**LAND OFF PUMP LANE  
RAINHAM  
KENT  
ME8 7TJ**

**INQUIRY DOCUMENT: Mott Macdonald Road Safety Audit**

Road Safety Audit  
Stage 1

8 April 2021

**Figure 4: Existing Toucan Crossing footway / cycleways.**

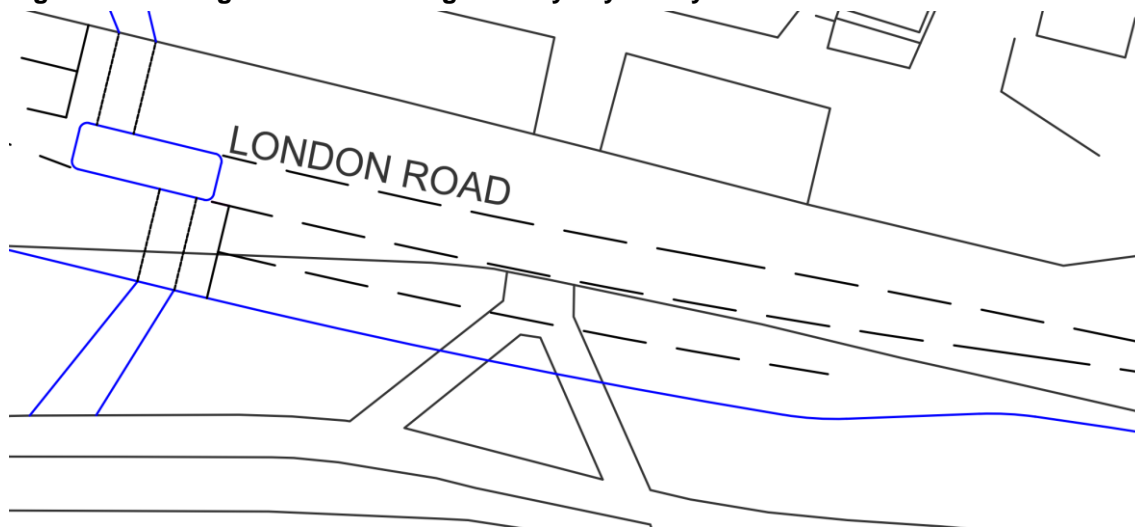
*Summary: Existing footway / cycleway associated with current crossing position should be removed.*

There is no indication if the existing footway / cycleway leading to the current crossing point are to be removed. Failure to remove the links may lead to pedestrians or cyclists attempting to cross at the existing crossing away from the relocated Toucan Crossing, increasing their vulnerability to being struck by passing vehicles.

It is recommended that the existing footway / cycleway links leading to the current Toucan Crossing are removed.
